**EDWARD B. WALSH & ASSOCIATES, INC.**  
*Complete Civil Engineering Design / Consultation Services*  
Lionville Professional Center  
125 Dowlin Forge Road  
Exton, PA 19341

Re: Preliminary/Final Plan for Cahill subdivision  
Westtown Township  
EBWA No. 4062

The following letter is being written to accompany the resubmission of the above referenced project. We have revised the plans in accordance with the July 11, 2018 letter from McCormick Taylor and the July 17 email from Bill Malin of Carrol Engineering. This letter's enumeration follows that of the consultant's letters.

SUBDIVISION PLAN

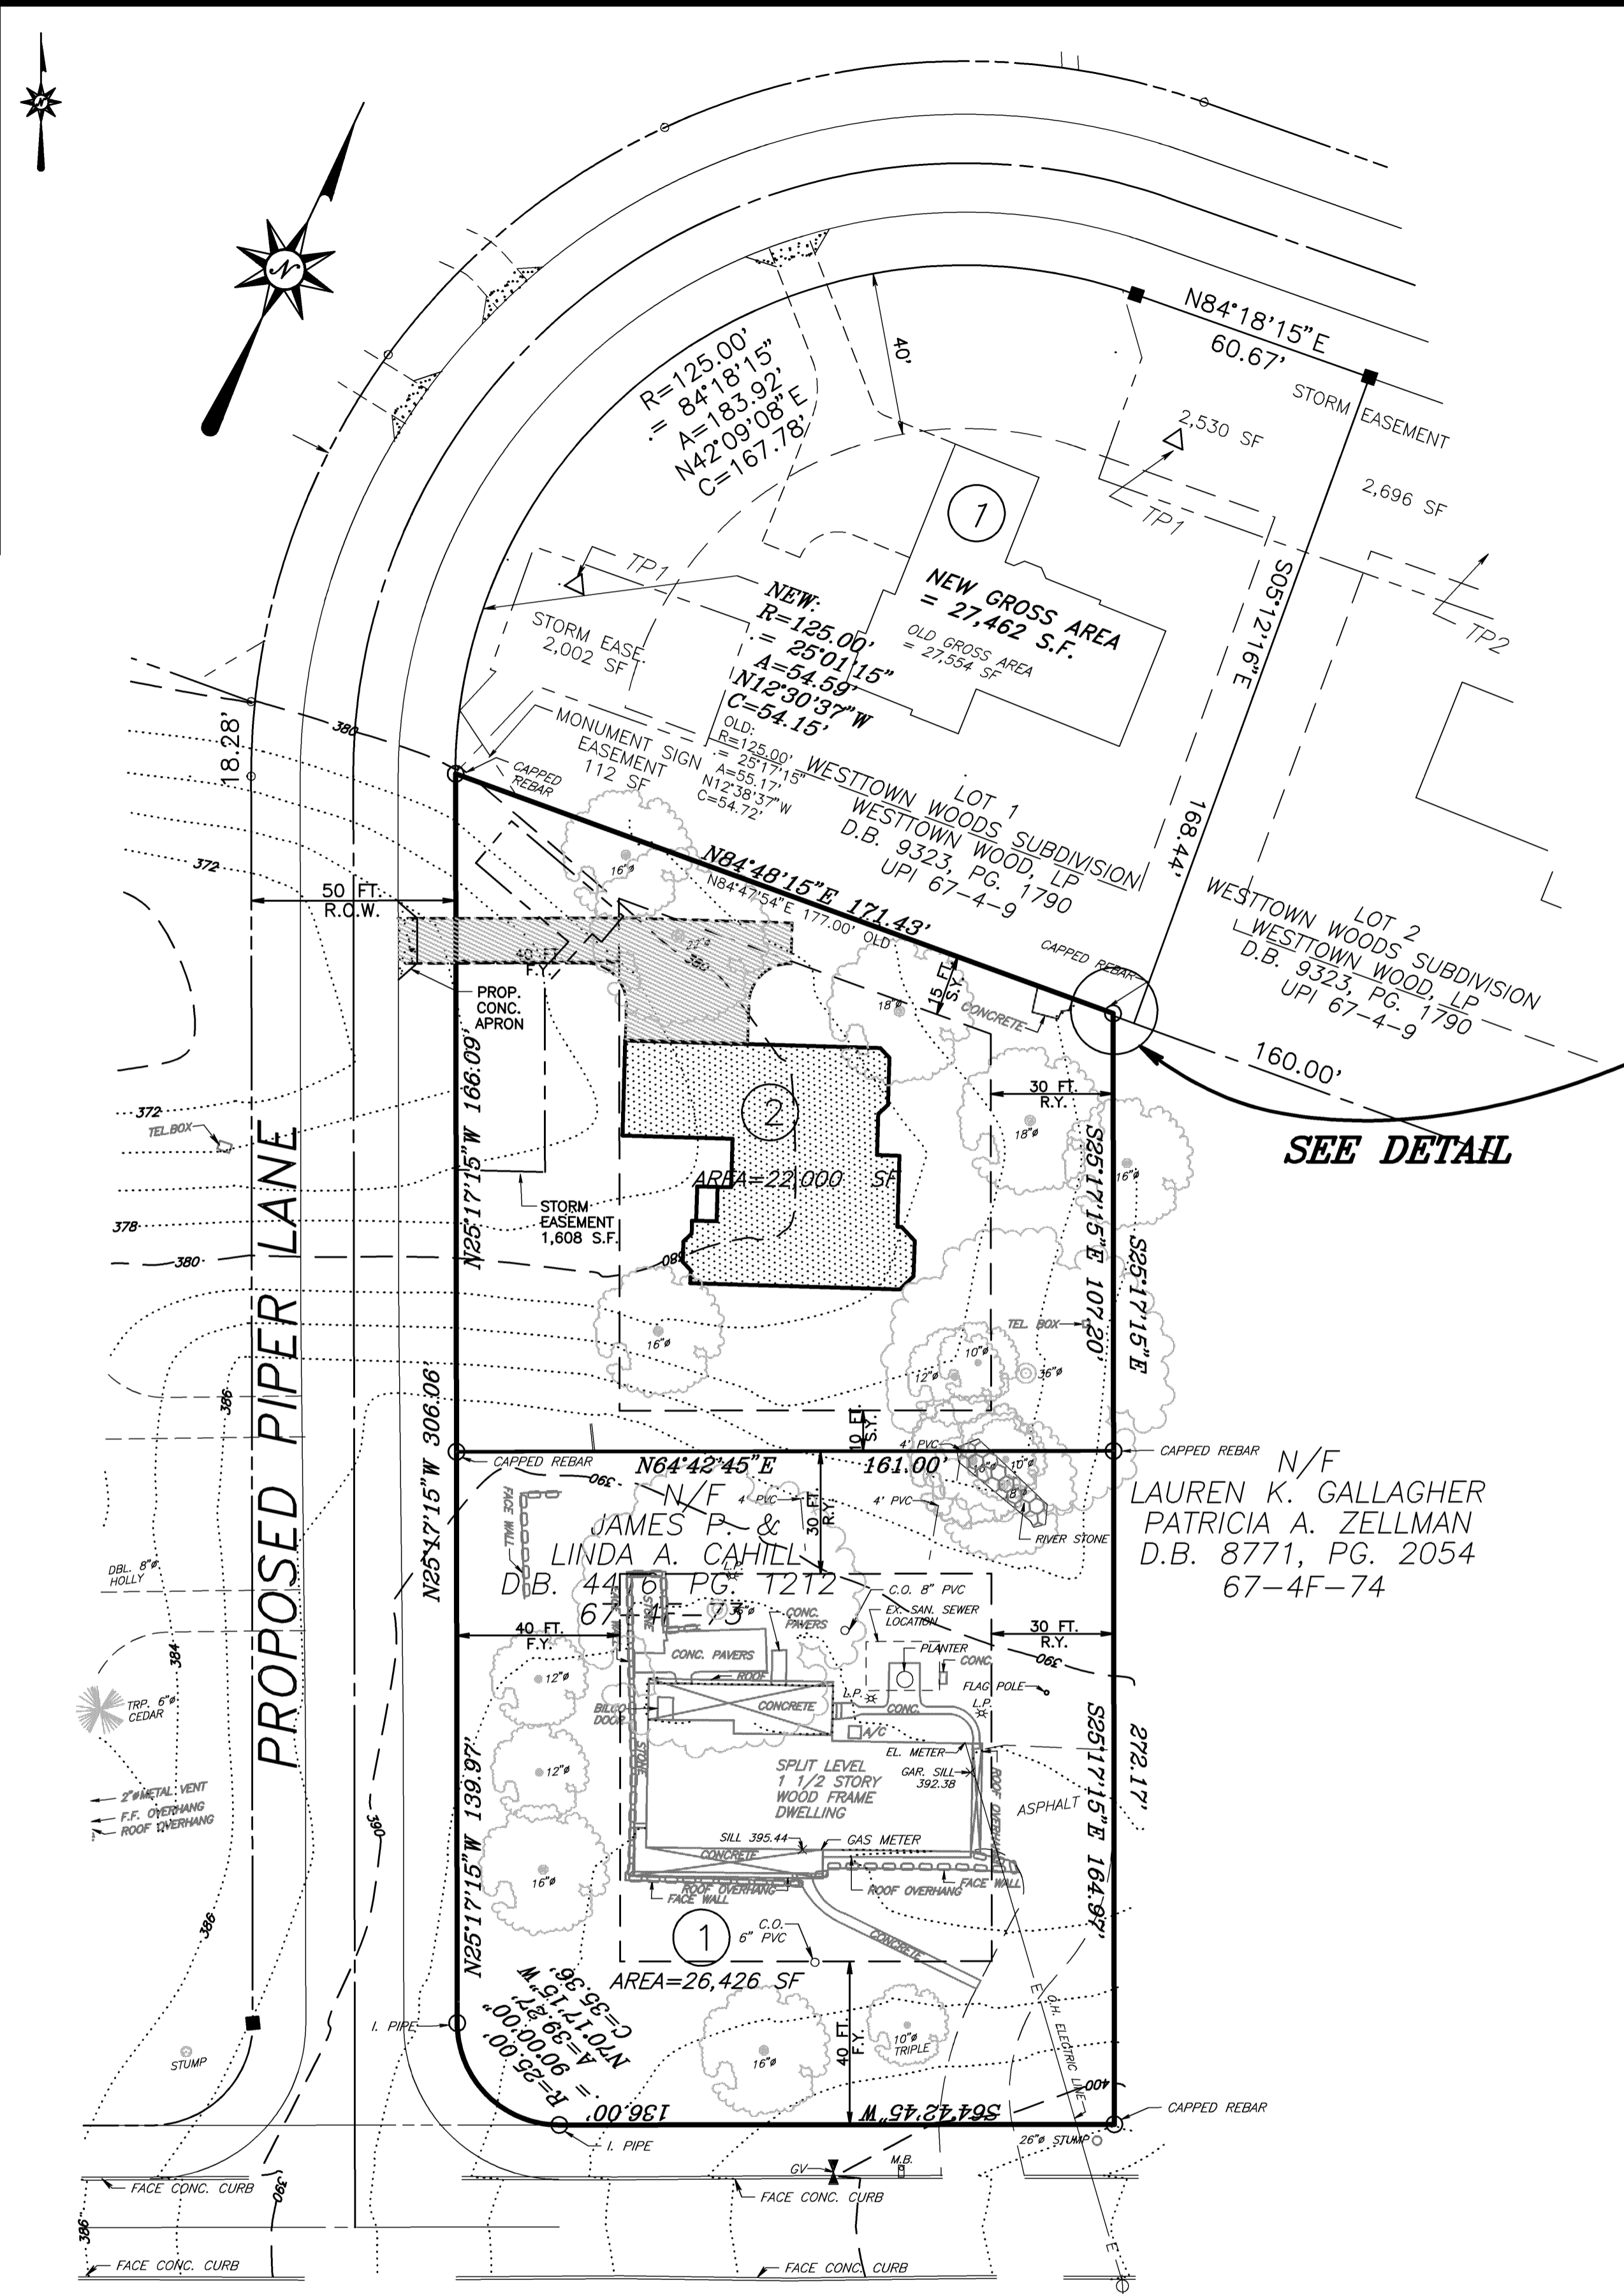
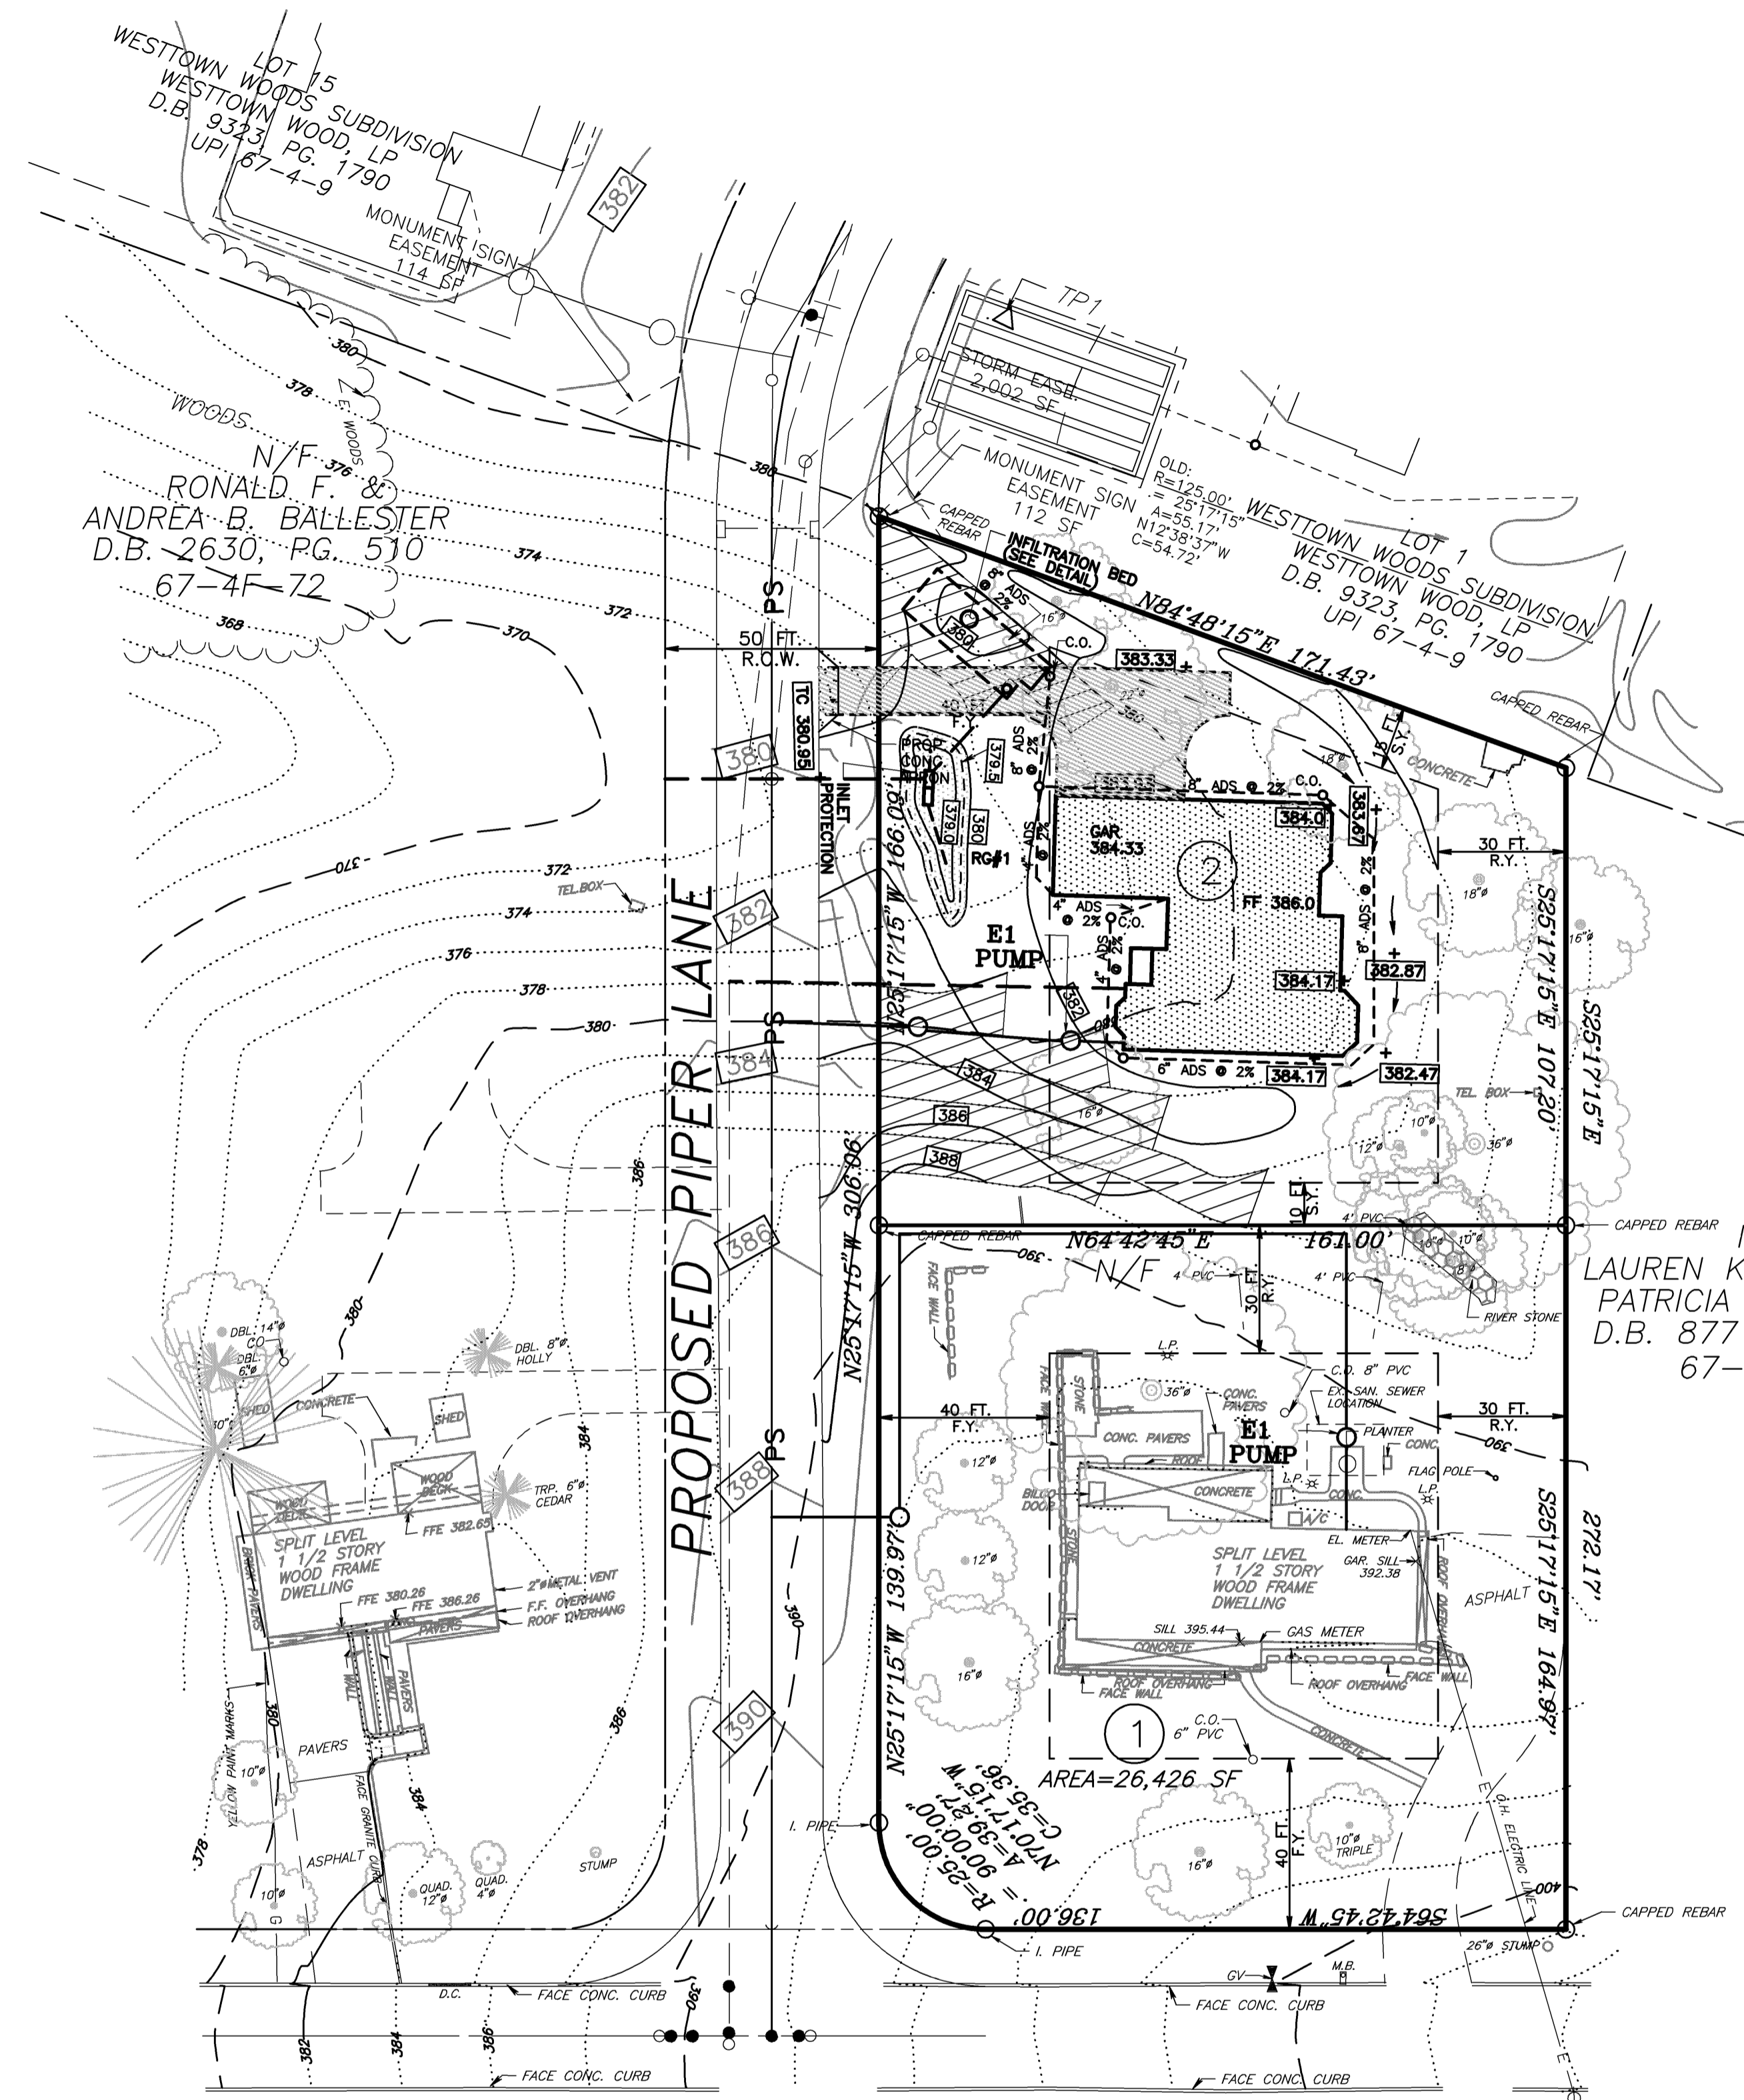
A waiver request from Section 149-600 to consider the plan preliminary and Final has been added to sheet 1.

1. Note 8 has been added to sheet 1 requiring the signed and sealed statement to be submitted with the building permit application. It seems to be more appropriate with that submission as it will include the final house layout and grading, as it may be less than what currently is presented.

2. The zoning data table on sheet one reflects the contiguous lot area.

3. We have requested a waiver to allow the plan to be considered both preliminary and final.
4. We have added a curb detail to sheet 8 and specified the Penn DOT 408 requirement in note 9 on sheet 1.
5. A driveway profile has been added to sheet 8.
6. We have added concrete apron to the driveway, however there is no sidewalk proposed on this side of Piper Lane as the grading necessary to install the sidewalk would require the construction of a retaining wall along the Cahill frontage.
7. The location of the existing sanitary sewer has been added to the plan.

WAIVER REQUEST: SECTION 149-600 TO ALLOW THE PLAN TO BE CONSIDERED PRELIMINARY & FINAL.
